Access Compliance Report

Public Rights-of-Way

(Curb Ramps)

Intersection ID: 28536	Main Street: SOUTH_STREAM_BV	Cross Street: W_TYVOLA_RD	Location: SE
ADA ID: A874D6372B62	Ramp Type: Perp	Initial Pass/Fail: Fail	Overall Compliance: No
Severity Score: 37.5			
Codes/Mitigation Info/Possible Solution		Field Measurements/Component Compliance

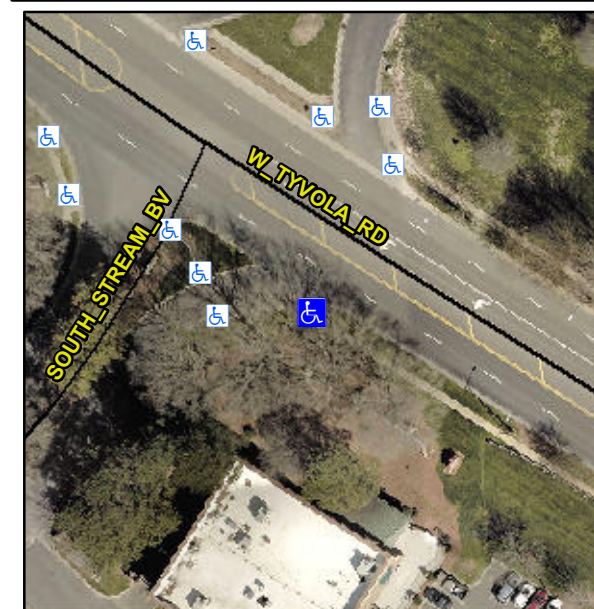
Not Found, R304.2.2, R304.5.3

Compliance	Description	Data	Compliance	Description	Data
N/A	Ramp Length (in)	33.0	No	Ramp Slope (%)	11.0
Yes	Ramp Width (in)	58.0	No	Ramp XSlope (%)	7.9
N/A	Flare Type LT	N/A	N/A	Flare Type RT	N/A
N/A	Flare Slope LT (%)	N/A	N/A	Flare Slope RT (%)	N/A
N/A	Flare Traversable LT?	N/A	N/A	Flare Traversable RT?	N/A
N/A	Landing Length (in)	N/A	N/A	DWS Provided?	N/A
N/A	Landing Width (in)	N/A	N/A	DWS Contrast?	N/A
N/A	Landing Slope (%)	N/A	N/A	DWS Length (in)	N/A
N/A	Landing X Slope (%)	N/A	N/A	DWS Full Width?	N/A
N/A	Landing Curb? (Y/N)	N/A	N/A	DWS Offset (in)	N/A
N/A	Shared Landing?	N/A			
N/A	Gutter Ponding?	N/A	N/A	Gutter Slope (%)	N/A
N/A	Gutter Lip Ht (in)	N/A	N/A	Gutter X Slope (%)	N/A
N/A	Painted X Walk1?	No	N/A	Painted X Walk2?	N/A
	X Walk 1 Direction	To N		X Walk 2 Direction	N/A
N/A	X Walk 1 Width (in)	N/A	N/A	X Walk 2 Width (in)	N/A
	X Walk 1 Slope (%)	2.7		X Walk 2 Slope (%)	N/A
	X Walk 1 X Slope (%)	3.6		X Walk 2 X Slope (%)	N/A

Remove & Replace Entire Ramp.
